Request Summary

- Major Development Plan and Variance for two new multi-tenant retail/restaurant buildings near Tech Center Dr and Hamilton Rd
 - Building A is ~10,000 SF; Building B is 6,500 SF
 - 8 total tenant spaces, 2 drive thrus, and 2 patio areas
 - Primary materials are burgundy and grey brick with metal accents
 - Materials consistent with MOB development and nearby Sheetz
 - 127 total parking spaces
 - Code requires 126 spaces
 - Includes 6 EV charging spaces as required

View from
Hamilton Rd

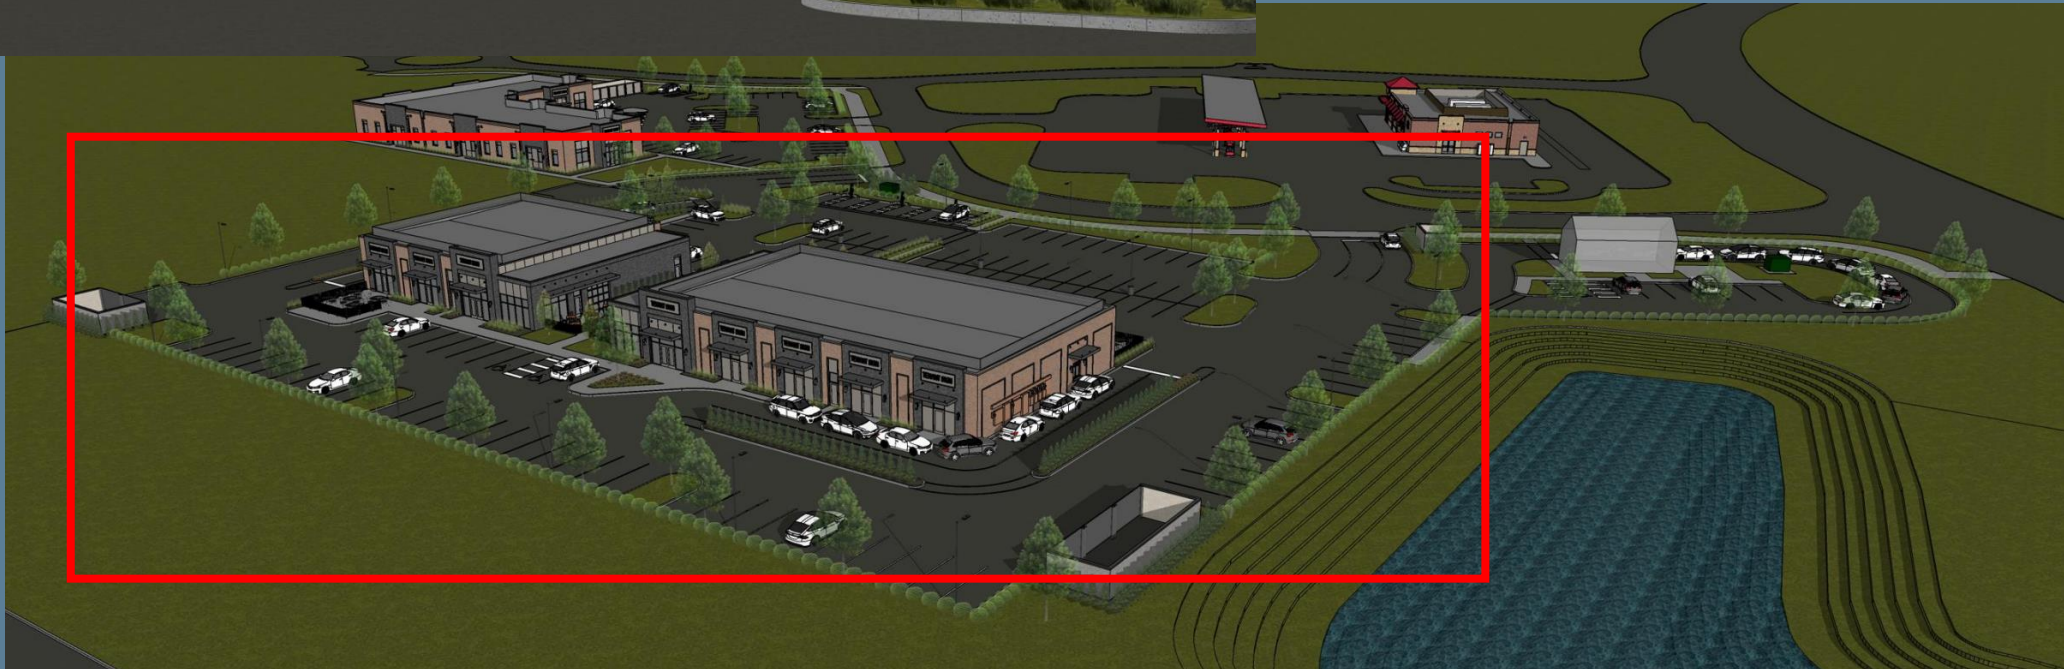
- Requested Variances
 - Ch 1107.01(g) – City-wide Design Standards
 - The ground floor primary façade of a commercial building must be at least 25% transparent glass
 - The 4 primary facades are between 3.4-25.4% glass
 - Ch 1109.01(a)(1) – Parking, Access, and Circulation
 - Parking areas must be located to the rear of the primary building
 - Two frontages makes this requirement impossible to meet
 - Ch 1109.02(e) – Setbacks and Structure Placement
 - Dumpsters must be to the rear of the primary building
 - Two frontages also make this requirement impossible to meet
 - 2 dumpster areas located near Hamilton Rd frontage

- Staff recommends approval of all three Variances
 - The applicant states the 25% glass requirement is difficult to meet due to the new Energy Code requirements from 2024
 - The site has two frontages, making it impossible to locate parking to the rear of the building
 - The parking lot is adequately screened from both ROWs
 - This also makes it difficult to locate the dumpster to the rear
 - Dumpster screening requirements are exceeded with a brick enclosure and landscaping
